## SERVICE BULLETIN #59

DATE: April 10, 1995  
TO: All Midship, Light Truck and Service Center Customers  
FROM: Joe Costello, Service Manager  
SUBJECT: ITEM #1:

THE NEW HALE GEARBOX SHIFT INDICATOR ASSEMBLY HAS  
TWO INDEPENDENT SWITCHES

# **SHIFT INDICATOR SWITCH**

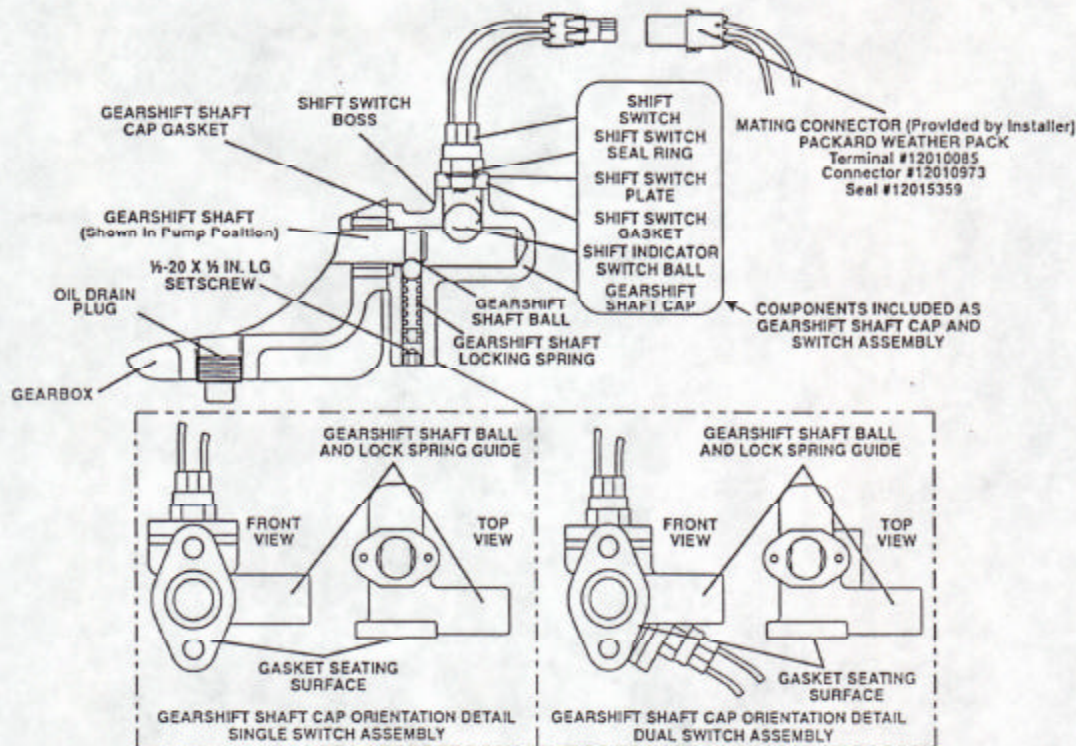
The Hale shift indicator switch is used to actuate the "PUMP ENGAGED" indicator light located on the driving compartment panel only. The switch SHALL NOT be used directly to achieve automatic transmission lock-up or actuate other indicator lights. The switch can be used to actuate relay coil(s) providing completion of electrical circuits in conjunction with other interlock switches for the "OK TO PUMP" and "WARNING, DO NOT OPEN THROTTLE UNLESS LIGHT IS ON" indicator lights as well as transmission lock-up and parking brake interlocks.

When a relay is placed into the circuit controlled by the shift indicator switch the maximum load limit of the switch (4 AMPS at 12 VDC) must not be exceeded by the light and relay coil(s). It is recommended that a single Potter-Brumfield P/N VF4-1511 Automotive SPDT relay (Form C) be used. If multiple relays must be connected use Potter-Brumfield P/N VF4-1511-SO1 suppressed coil relay. It is up to the OEM installer to provide the proper brake, transmission and engine safety interlocks. The relays listed above are readily available and provide both normally open and normally closed contacts.
